PLAN
 SHOWING LINE LAYOUT AND HORIZONTAL ELBOWS

B	9/2/64	P7. REV'D FROM 3/0\"/>		
NO.	DATE	DESCRIPTION OF REVISION	CHK.	APP'D.
THIS PRINT IS THE PROPERTY OF ARMCO DRAINAGE & METAL PRODUCTS OF CANADA LTD. AND IS LENT WITHOUT CONSIDERATION OTHER THAN THE BORROWER'S AGREEMENT THAT IT SHALL NOT BE REPRODUCED, COPIED, LENT OR DISPOSED OF, DIRECTLY OR INDIRECTLY, NOR USED FOR ANY PURPOSE OTHER THAN THAT FOR WHICH IT IS SPECIFICALLY FURNISHED. THIS PRINT IS LENT SUBJECT TO RETURN ON DEMAND.				
METRO WINNIPEG WATERWORKS DIV.				
CHARLESWOOD - ASSINIBOIA FEEDER MAIN				
24\"/>				
GUELPH ORDER NO 50-7663				
DATE AUG 31 DRAWN MK CHECKED GT APPROVED SCALE DO NOT				FILE
ARMCO DRAINAGE & METAL PRODUCTS OF CANADA LTD.				DRAWING NO. 7183 / 64B

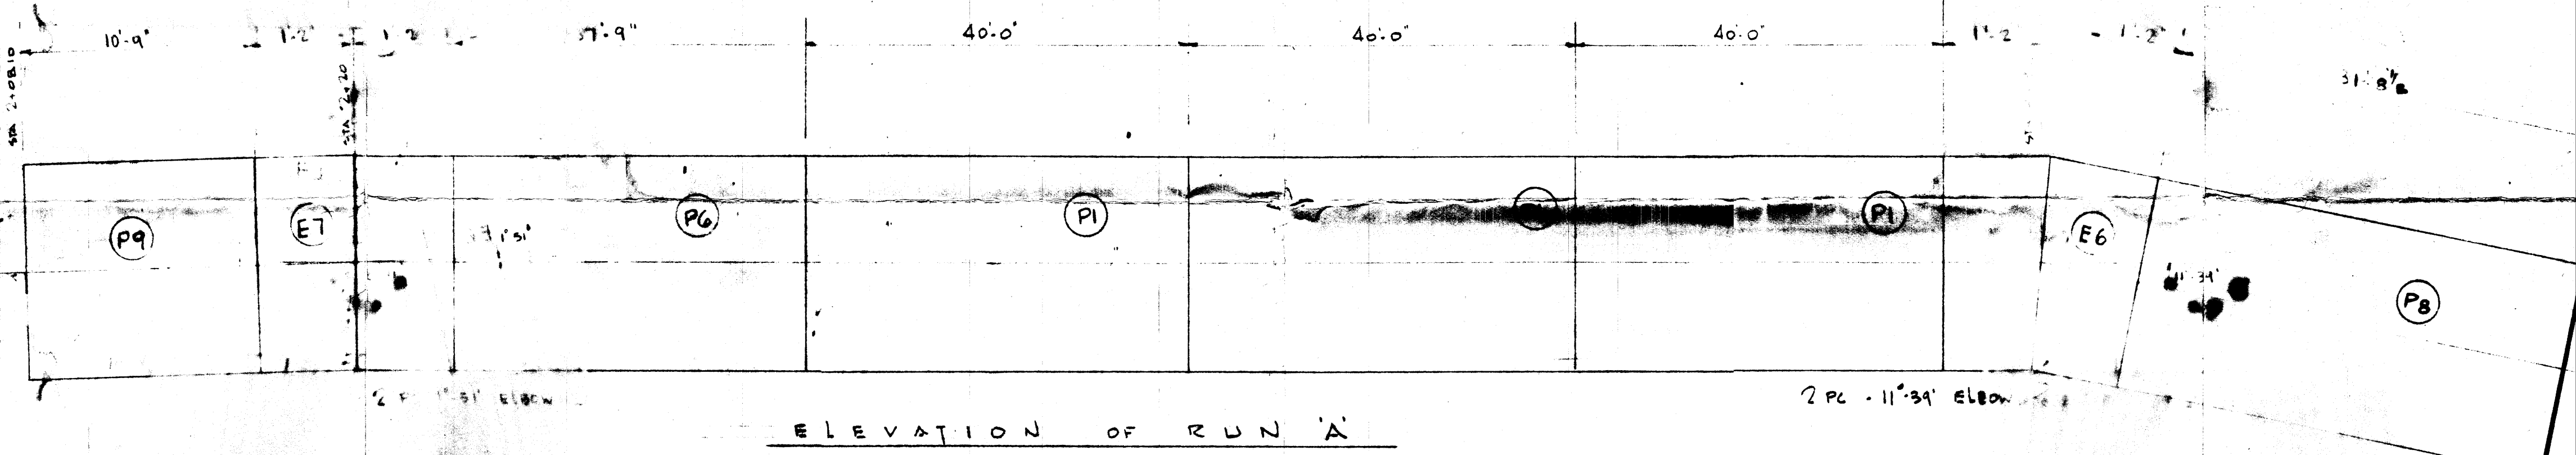
Flanges exposed to check for leakage.
 Partially exposed, but flange underwater. Results Not Conclusive.

ELEVATION OF RUN C

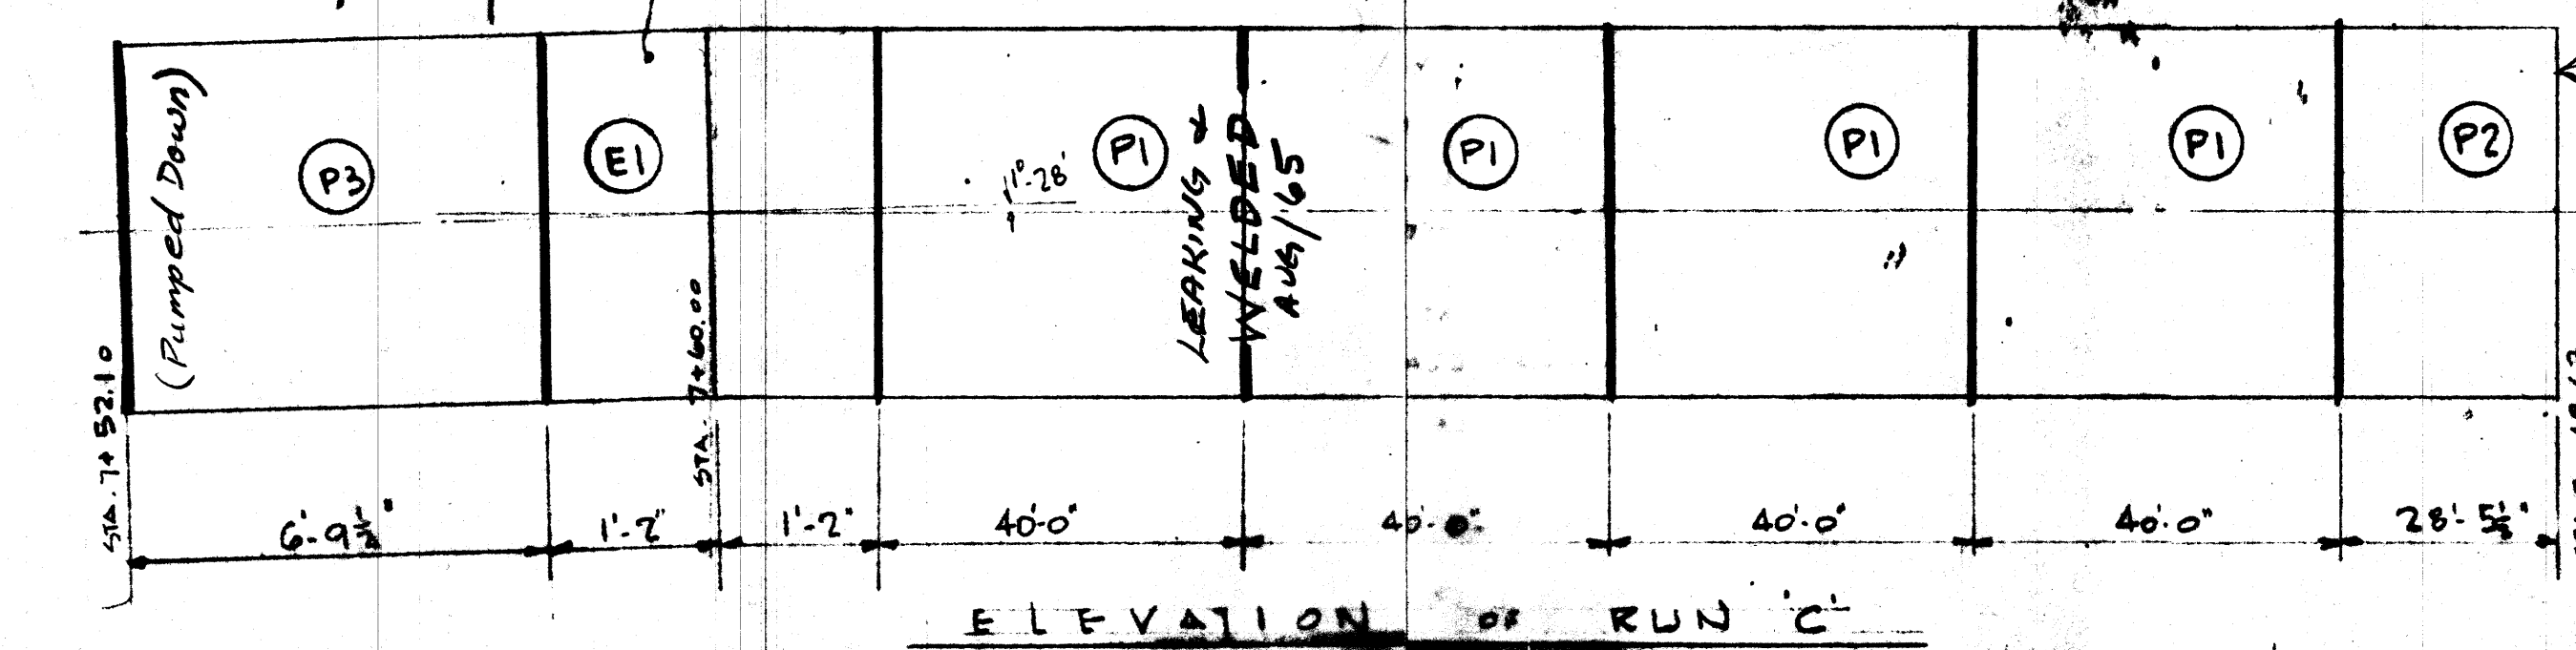
Connections made by Borgers was leaking. Bolts tightened by Borgers + found to be not leaking with line pressure. March/65.
